Doc #: 87-138

To: X3T9.2 Committee

From: Jim Schuessler, National Semiconductor

Subject: Fast SCSI

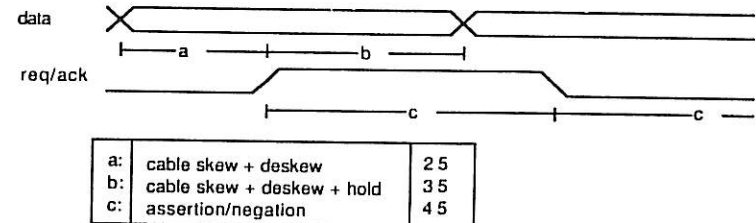
I propose a set of Fast SCSI timing parameters derived from the chart above.

Table	SCSI-2	Value
g	Fast Cable Skew Delay	5
h-n	Fast Deskew Delay	17 shown, round to 20
o	Fast Hold Time	5 shown, allow 10
*	Fast Assertion Period	45
*	Fast Negation Period	45

\* The Assertion and Negation periods are derived from isolated pulse measurements and represent a comfortable minimum pulse width which has the advantage that it can be produced from a 20MHz. clock.

Graphically, the new minimum times appear like this:

Proposed Changes to SCSI-2 doc.:

Sec. 4.7.X: Fast Assertion Period (45 nanoseconds)

Sec. 4.7.X: Fast Cable Skew Delay (5 nanoseconds)

Sec. 4.7.X: Fast Deskew Delay (20 nanoseconds)

Sec. 4.7.X: Fast Hold Time (10 nanoseconds)

Sec. 4.7.X: Fast Negation Period (45 nanoseconds)
